SERVICE LETTER NO. SL-1

EFFECTIVITY: Rockwell Commander 112 S/N 3 through 79

SUBJECT: Rudder Assembly

Figure 1.

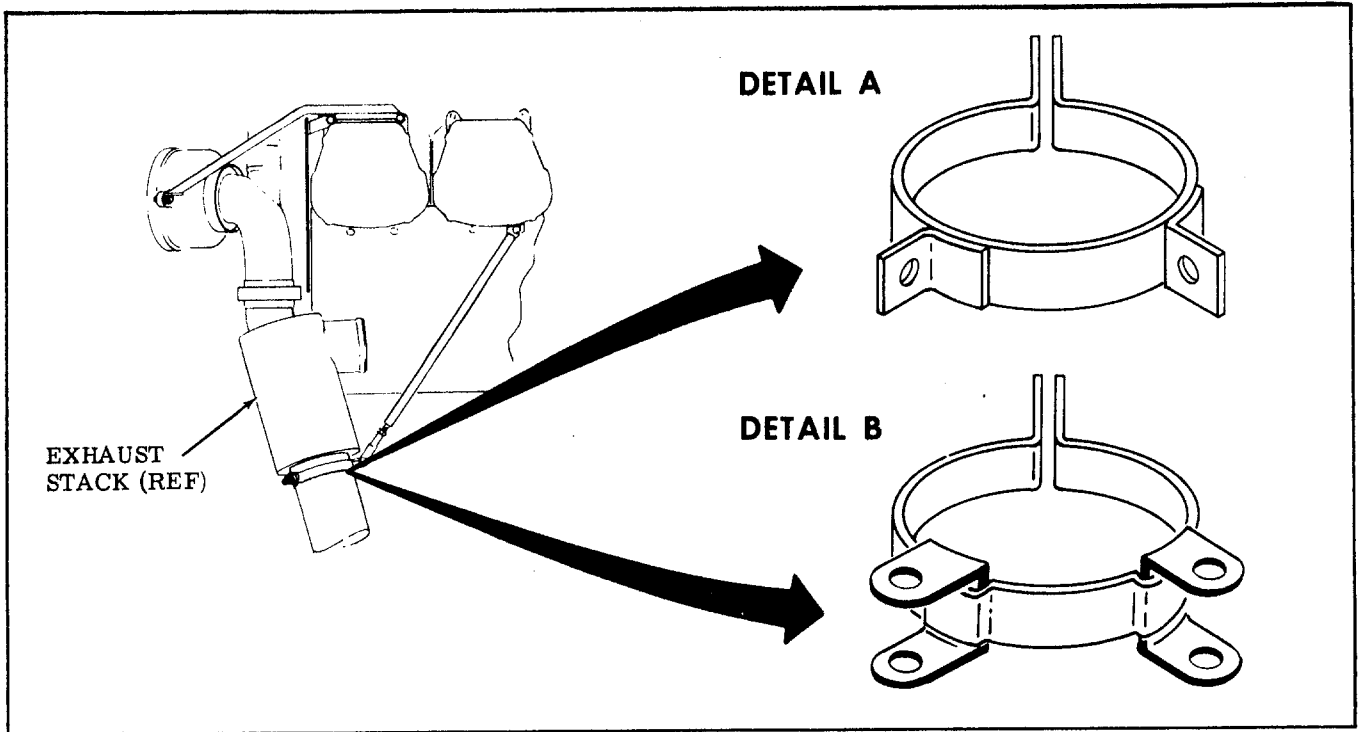
IF THE EXHAUST STACK STRUT CLAMP IS THE TYPE OF CLAMP AS SHOWN IN DETAIL "A" OF FIGURE 1., COMPLY WITH PART I ONLY OF THIS SERVICE LETTER.

IF THE EXHAUST STACK STRUT CLAMP IS THE TYPE OF CLAMP AS SHOWN IN DETAIL "B" OF FIGURE 1., COMPLY WITH PART II ONLY OF THIS SERVICE LETTER.

Figure 2.

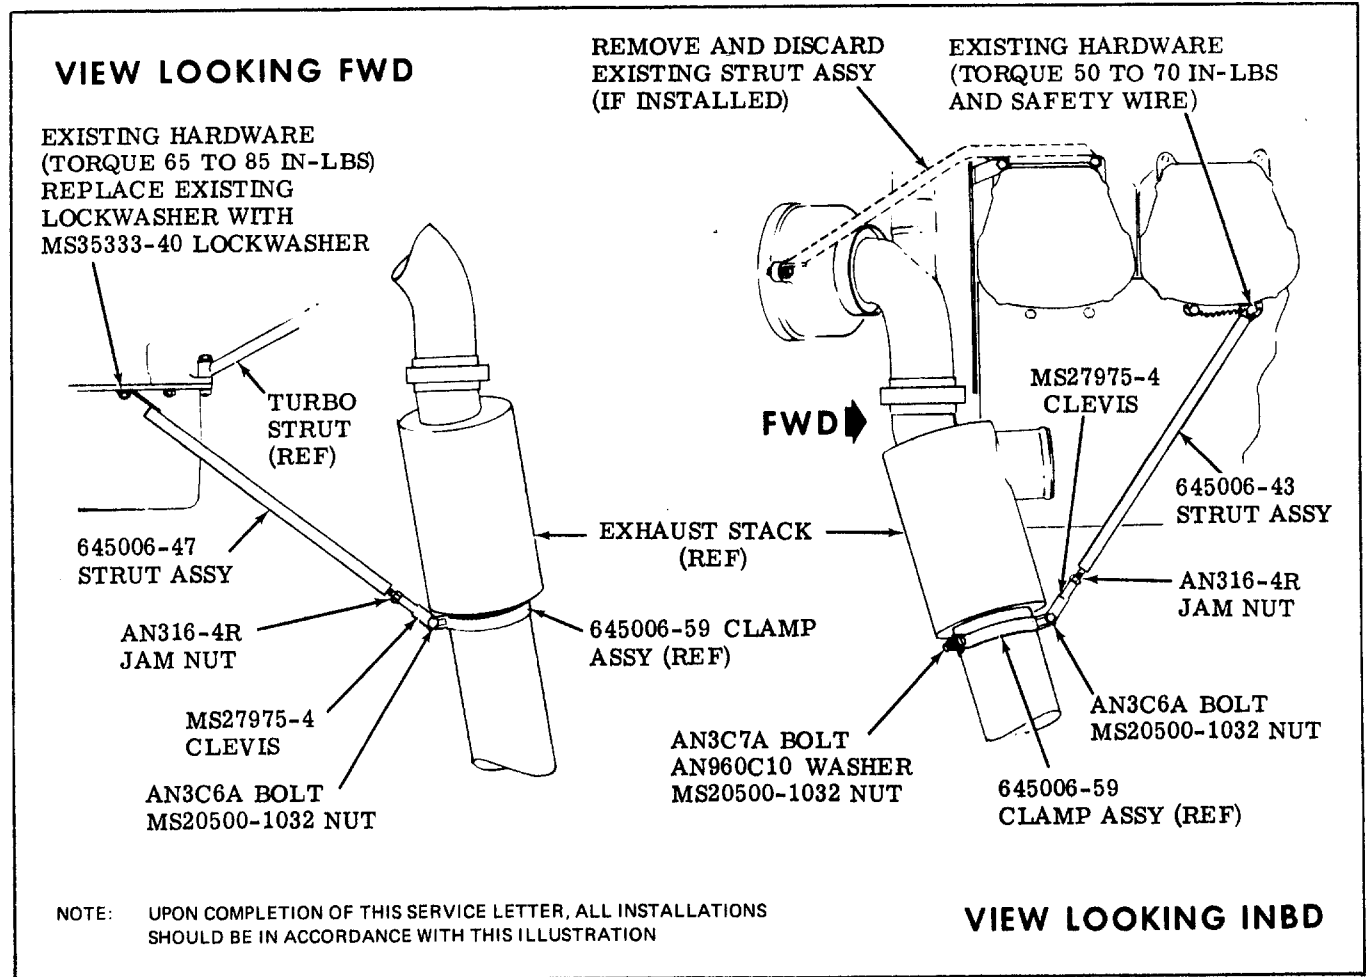
5. Install 645006-43 strut assembly, 645006-47 strut assembly and MS35333-40 lockwasher (under nut on upper end of -47 strut assembly) on engine and temporarily connect to clamp assembly installed in step 3. (see Figure 2.).
6. Loosen exhaust stack clamp, position exhaust stack to center of cutout in engine cowling and adjust strut assemblies to secure exhaust outlet in the centered position in cutout with a minimum clearance of 0.50-inch and tighten exhaust stack clamp assembly and all nuts as required to relieve all possible installation pre-load.
7. Install upper cowling on engine.
8. Fill out and mail Compliance Card and specify that Part I has been accomplished.
9. Proceed to RECORD COMPLIANCE.

1. Remove upper cowling from engine.
2. Remove and discard existing upper strut assembly from engine and retorque nuts on engine 50 to 70 inch-pounds (see Figure 2.).
3. Remove and discard existing clamp assembly from exhaust stack (see Figure 2.).
4. Install 645006-59 clamp assembly on exhaust stack and existing strut assemblies using existing hardware (see Figure 2.).

Figure 1.

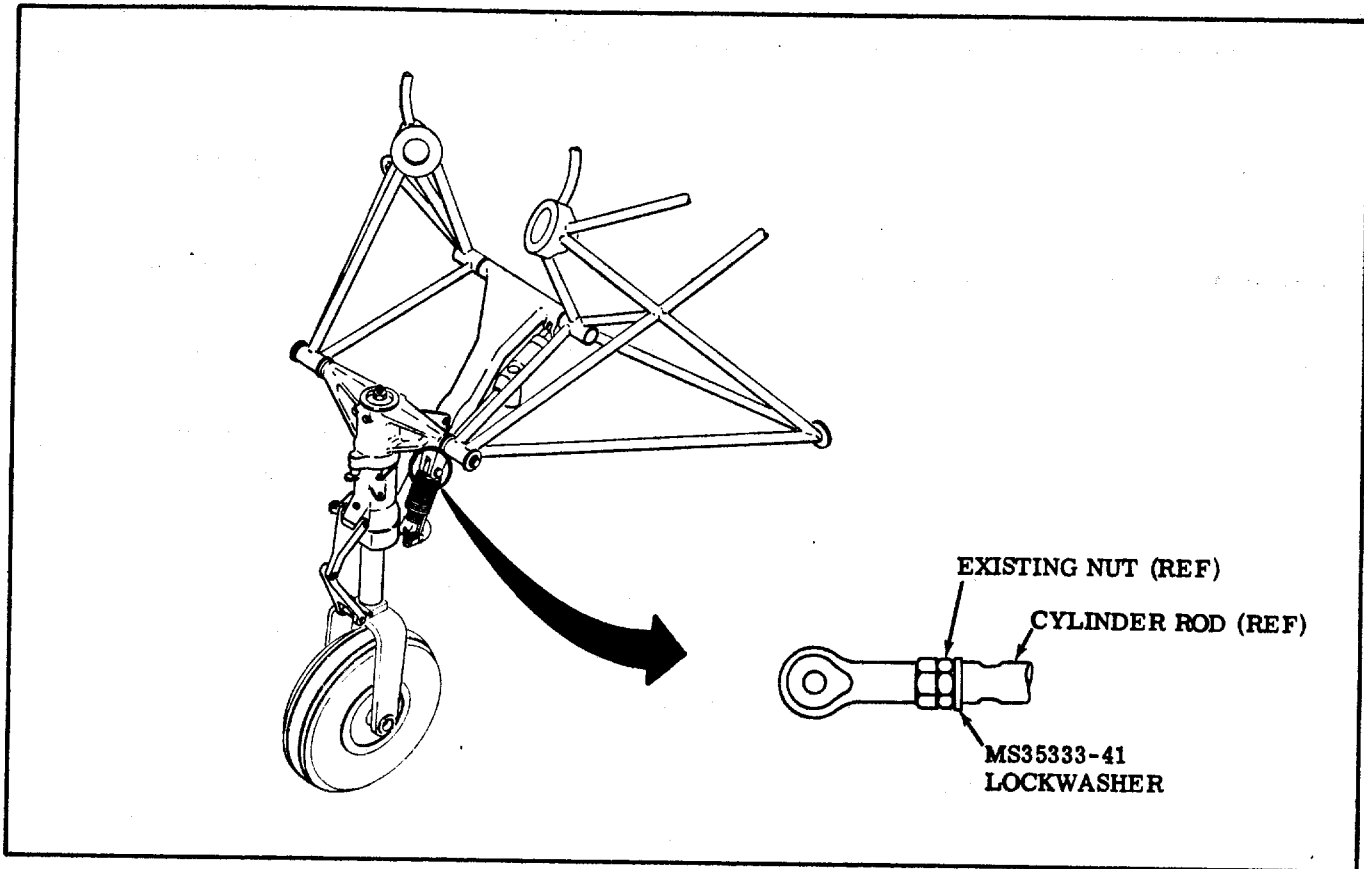
1. Jack airplane as outlined in the Airplane Maintenance Manual, Section II.
2. Disconnect nose landing gear retract cylinder at landing gear trunnion.
3. Loosen rod end nut and remove rod end.
4. Install MS35333-41 lockwasher and existing rod end on nose landing gear retract cylinder and run nut and rod end all the way down on threads of retract cylinder (see Figure 1.).
5. Check drag brace assembly at knuckle area to assure that drag brace is resting on stop.

6. Extend cylinder piston to maximum length and adjust rod end hole to 0.250 (\pm 0.03) inch past hole in trunnion for cushion. Finger tighten nut against cylinder rod.
7. Realign hole in rod end with hole in trunnion and install existing hardware.

Figure 2.

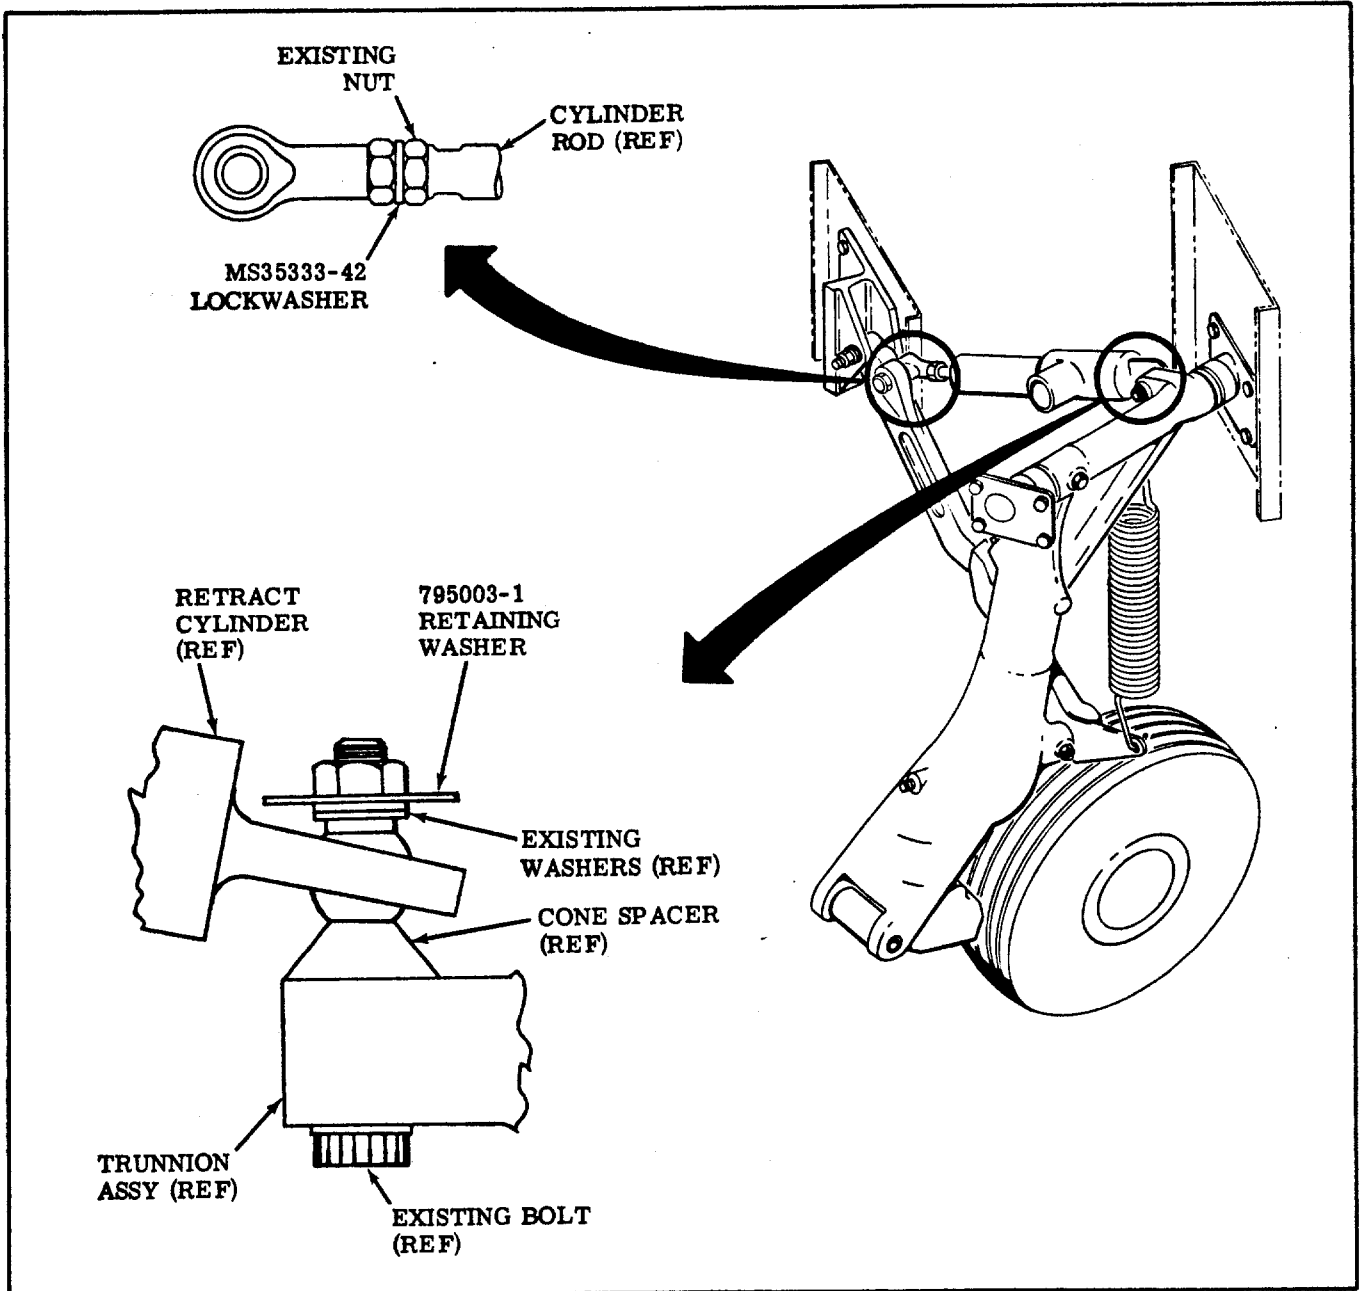
8. Collapse nose landing gear as necessary to gain access to rod end nut and torque nut 60 to 85 inch-pounds against cylinder rod and lockwasher while holding cylinder rod securely.
9. Remove bolts attaching the inboard end of the left and right main landing gear retract cylinder to the side brace assemblies.
10. Loosen rod end nut and remove rod end.
11. Install MS35333-42 lockwasher and existing rod end on left and right main landing gear retract cylinder (see Figure 2.).

Figure 3.

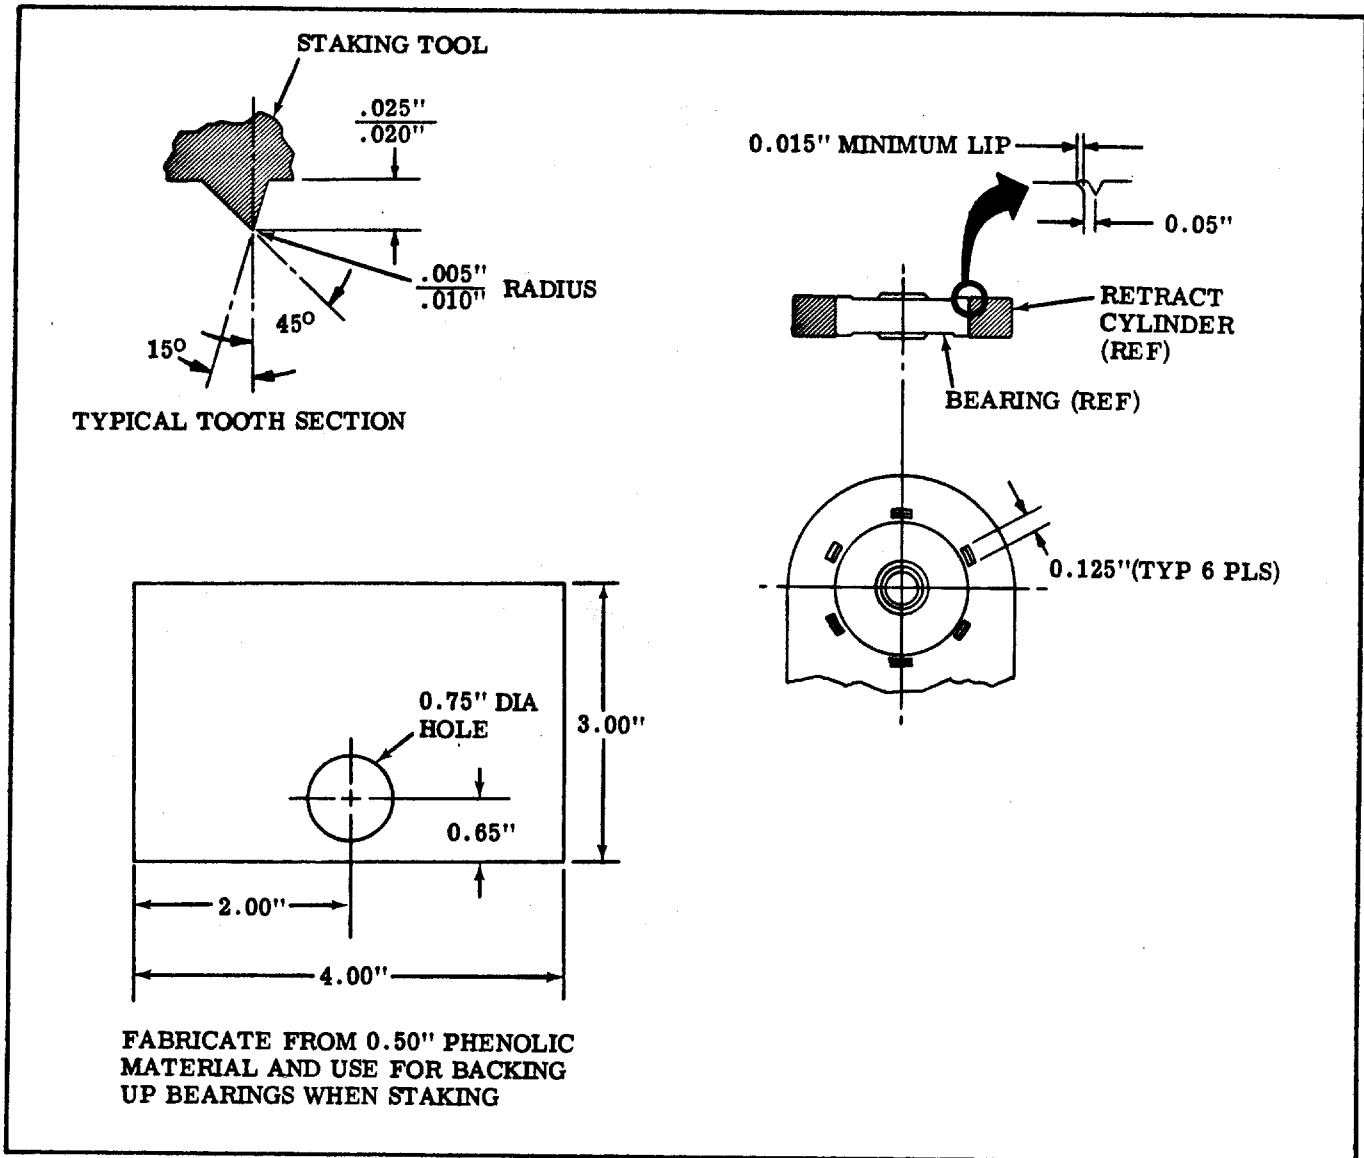
- b. Inspect cylinder end plug bearings to assure that the bearings are properly staked as shown in Figure 3.

- c. If bearings are properly staked, proceed to step 12.e.
- d. If bearings are not properly staked, hand stake bearings six (6) equal spaces around bearing (see Figure 3.) using a staking tool that conforms to dimensions shown in Figure 3.

Fabricate a block from 1/2-inch phenolic material for backing up bearing when staking (see Figure 3.).

Figure 1.

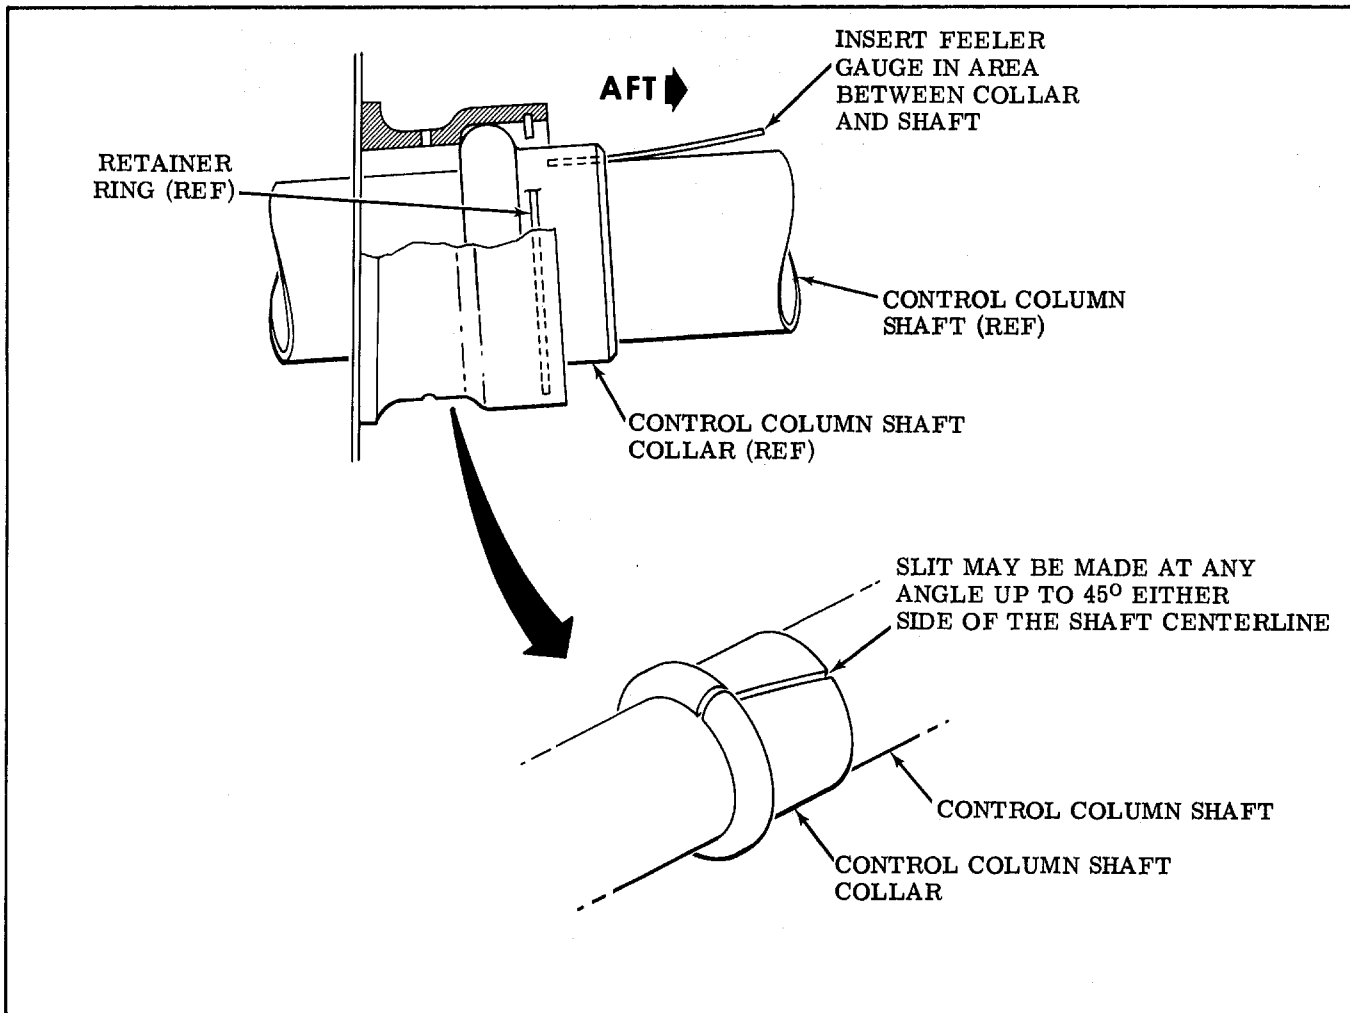
- d. Cut a slit in collar with a hacksaw blade or equivalent cutting tool. Maximum width of cut to be 0.050-inch (see Figure 1.).
